# CITY OF PORTLAND

Permit Number: 081227

This is to certify that BPI REALTY LLC /HardyPond construct  
has permission to install framed canopy over existing entry ramp at main entrance

AT 1039 RIVERSIDE ST - unit 4

**S1.1**

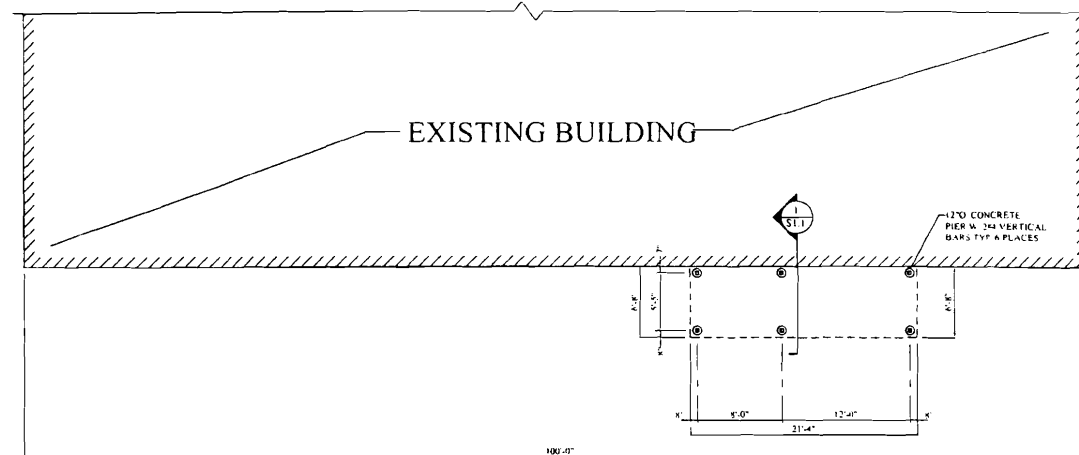
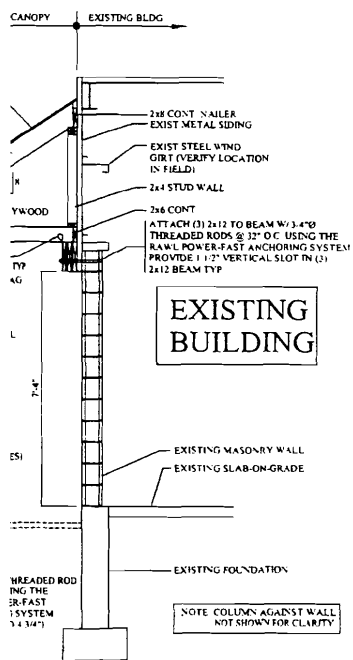
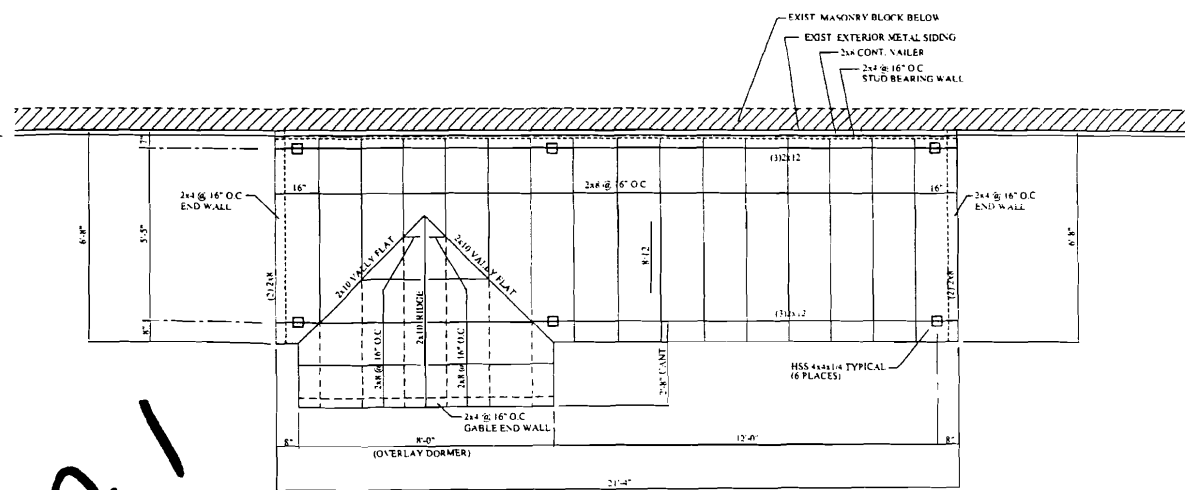
- 1) A minimum of class C roof covering is required
- 2) Approved based on plans submitted Dec. 17, 2008 to be built as non-combustible construction, consistent with the building type.
- 3) Separate permits are required for any electrical, plumbing, HVAC or exhaust systems. Separate plans may need to be submitted for approval as a part of this process.
- 4) Application approval based upon information provided by applicant. Any deviation from approved plans requires separate review and approval prior to work.

10/27/2008-tmm: HOLD - need fire rating between structures due to proximity based on table 602 in IBC - calle dJeff @ hardy pond construction, or to be built as non-combustible.

12/17/2008-ldobson: Jeff from Hardy Pond dropped by a plan showing the canopy built non-combustible
